## Nebraska Regional Haze Progress Report Consultation

# Attachment 1: National Park Service (NPS) Technical Comments on Nebraska's Draft Regional Haze Progress Report for the Second Implementation Period (2018-2028)

May 2, 2025

Figure 1. Haze Index on Most Impaired Days, Badlands National Park 2014–2023.  
<https://views.cira.colostate.edu/fed/Express/AqrvTools.aspx>

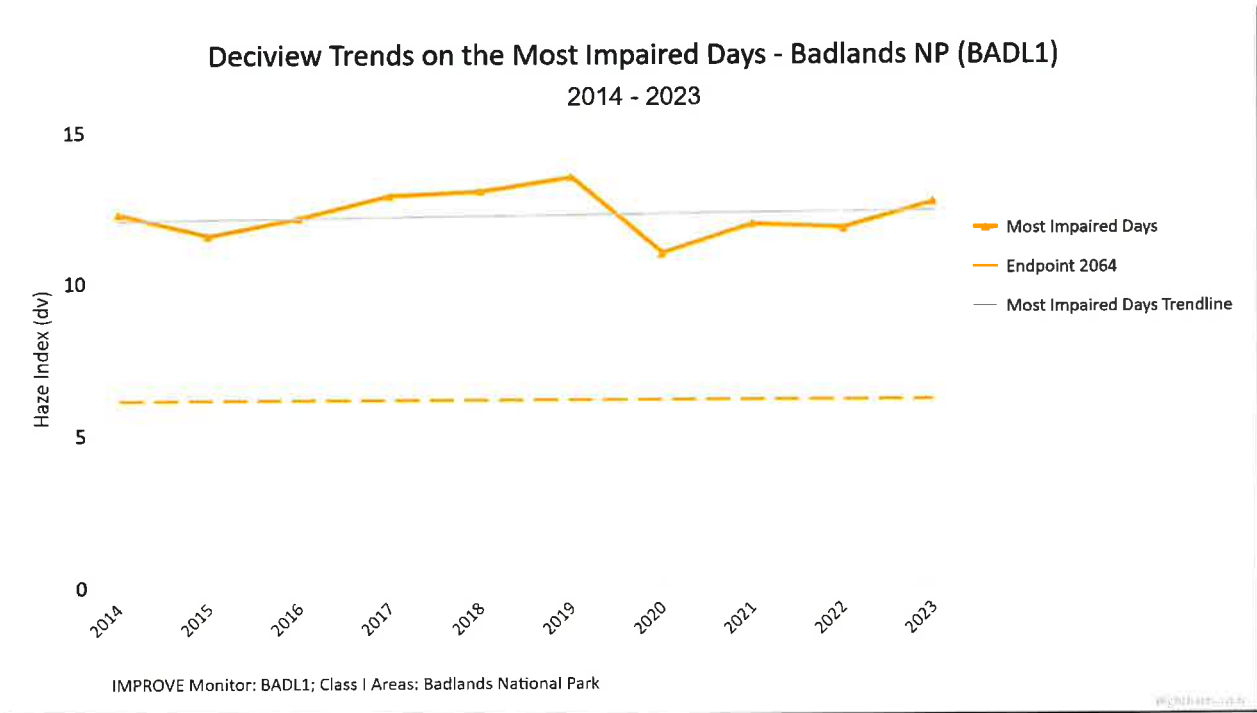
- Given that the most recent four-year period shows deciview increases on the most impaired days, why does the report conclude that current plan elements and strategies are sufficient to enable South Dakota to meet its reasonable progress goals?
- How will the current plan elements and strategies ensure that haze does not continue to increase on the most impaired days?

The NPS review of most impaired days (MID) visibility data from Badlands and Wind Cave National Parks in South Dakota confirms that visibility on these days has been deteriorating since 2020 and has not improved over the past 10 years (see figures below). Nebraska's GGS is the single largest contributor to haze-causing emissions affecting these Class I areas. The NDEE progress report shows increasing emissions from GGS at the same time visibility on MID is degrading at the parks. NDEE observes that "*...current visibility conditions (most impaired days, in deciviews) are better than the established RPGs for the second period.*" How will the NDEE plan address the worsening visibility conditions on MID for these parks and ensure that the South Dakota reasonable progress goals can be met?
